Process Change Notification **CN06-2018**

SATO Marking Change of NON COLOR TMD2725x

Proposal 2v1 for AOI mark to distinguish TMD2725 from TMD3725

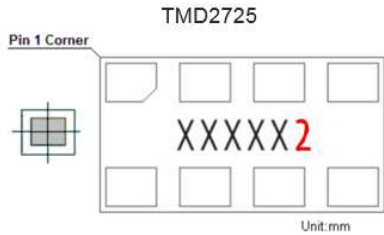
- add one laser mark (TRIANGLE) on TOP SIDE of module
- add one digit on BOTTOM SIDE (indicated in red)
- XX on TOP SIDE indicates dynamic trace code

- No additional mark on TOP SIDE
- No additional digit on BOTTOM SIDE
- XX on TOP SIDE indicates dynamic trace code
